**From:** david.distel@exeloncorp.com  
**Sent:** Monday, March 21, 2011 11:20 AM  
**To:** Jessie, Janelle; Hale, Jerry  
**Subject:** Exelon Letter - Response to Hydrology Audit Information Needs Items 41b and 47  
**Attachments:** NP-11-0013 - Hydrology Audit information Needs Response INH 41b, 47.pdf

NP-11-0013  
March 21, 2011

Subject: Exelon Nuclear Texas Holdings, LLC  
Victoria County Station Early Site Permit Application  
Hydrology Audit Information Needs Response  
NRC Docket No. 52-042

Figure 2.4.12-C-2 Plan View of Model Grid

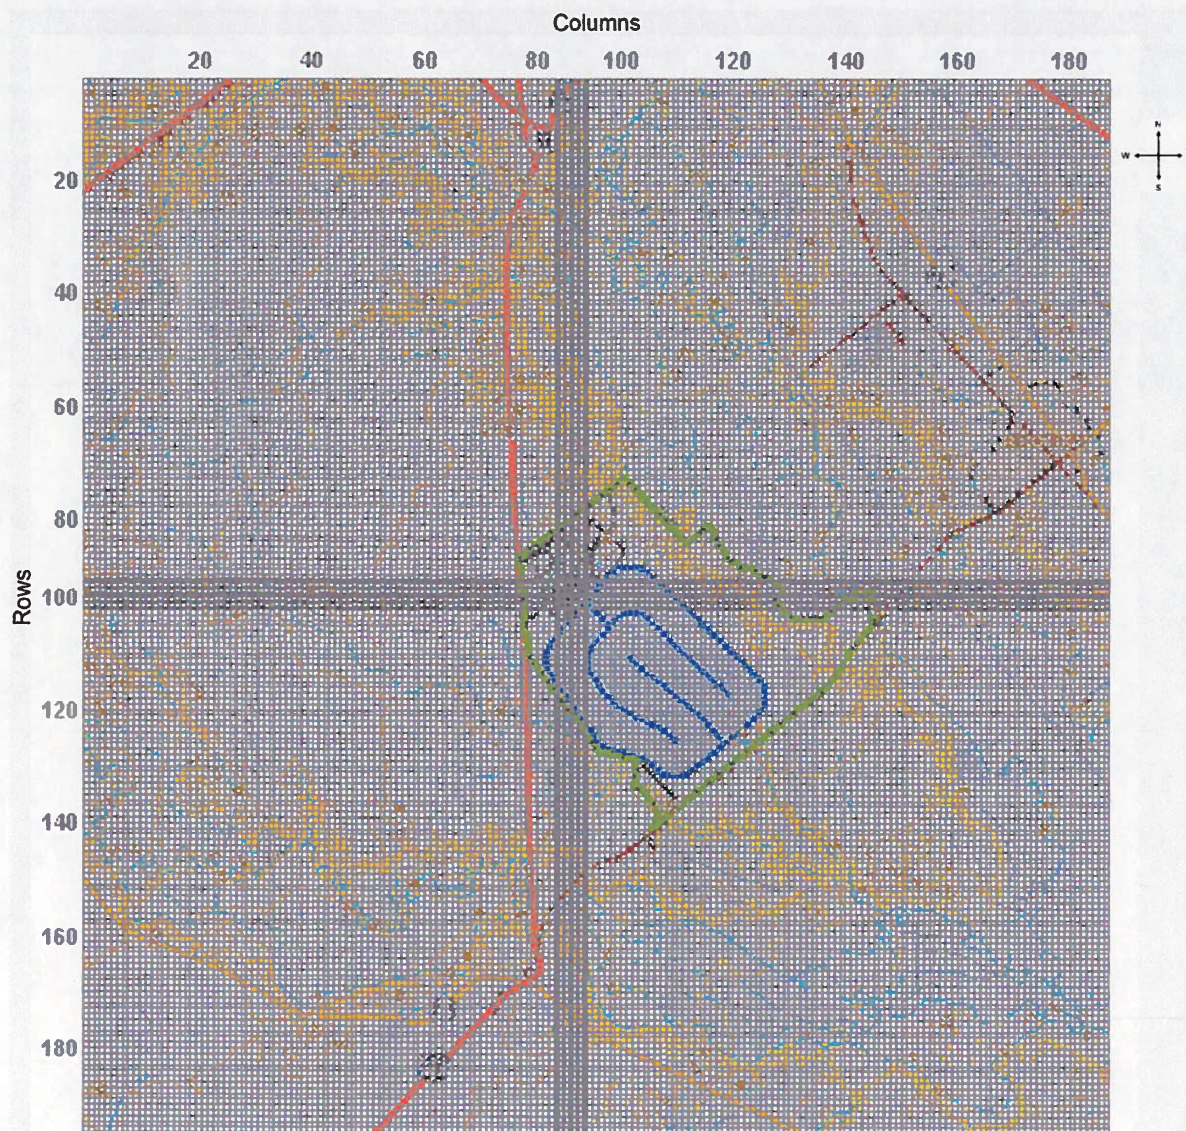
Please provide a figure of the model grid with rows and columns clearly numbered. Figure 2.4.12-C-3 is identified as a cross section through "Model Row 92" with no cross section location information. Also, provide elevation contour maps of the layer surfaces used in the model that delineate data point locations used to derive the surfaces.

1. Revise SSAR Figure 2.4.12-C-2 to include grid numbering (rows and columns).
2. Revise SSAR Figure 2.4.12-C-3 to include "East-West" direction labels.
3. Provide elevation contour maps of the layer surfaces used in the model that delineate field data point locations used to derive the surfaces (open item).

Revisions to Figures 2.4.12-C-2 and 2.4.12-C-3 addressing items 1 and 2 are provided in this response.

Revisions to Figure 2.4.12-C-2 (SSAR page 2.4.12-C-44) and Figure 2.4.12-C-3 (SSAR page 2.4.12-C-45) are provided on the following pages.
